## Video Products Technical Bulletin 30-2006-158

SUBJECT: REUSE CP303 WHEN REPLACING THE A BOARD

MODEL: PVM-1354Q  
PVM-1454QM

**Figure 1**

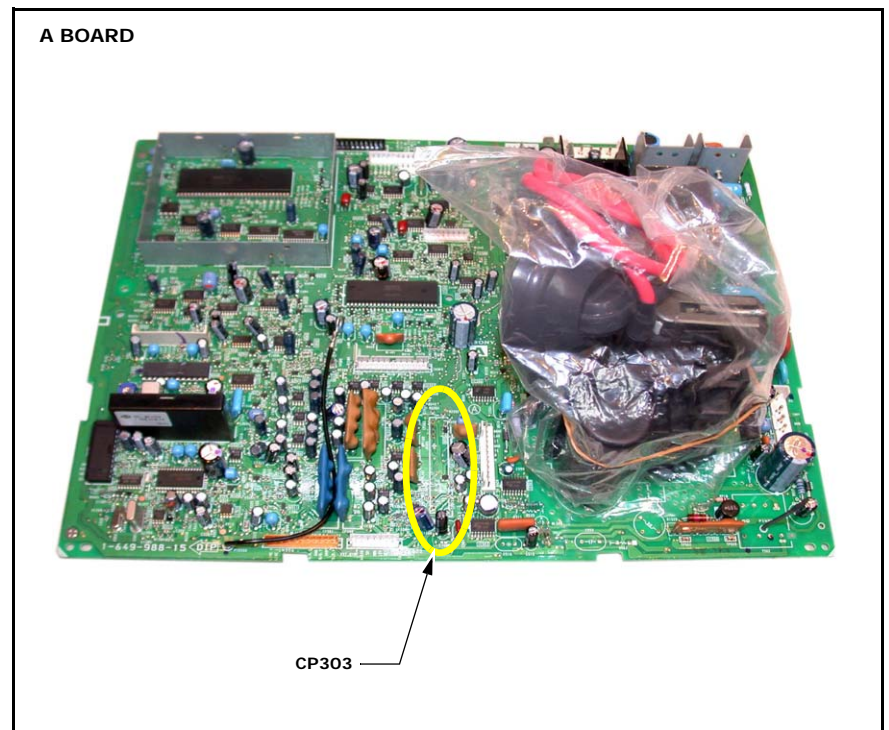
When you replace the A board (A-1297-195-D), remove CP303 (com filter block (CFB-4), 1-466-162-61) from the former board and install it on the new board.

The new A board does not contain CP303, and CP303 is no longer available as a service part. (See Figure 1.)
